SERVICE BULLETIN #1084

SUBJECT **PISTON RING SETS**

MODEL **7-55**

DATE 2/29/60

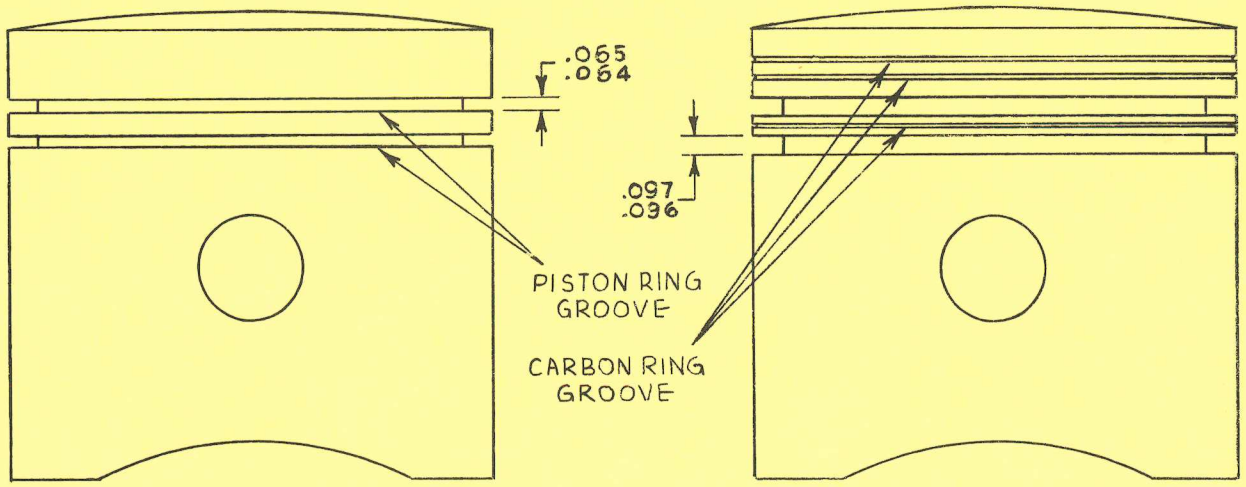
Two Piston Ring Sets, P/N's 24804 and 28809, are available for service replacement on Model 7-55 chain saw engines. Use P/N 24804 Ring Set with the wide groove piston, and P/N 28809 Ring Set with the narrow groove piston (see illustrations below).

NOTE: Model 7-55 engines have used pistons with and without carbon ring grooves. The presence or lack of a carbon ring groove does not affect interchangeability of 7-55 pistons.
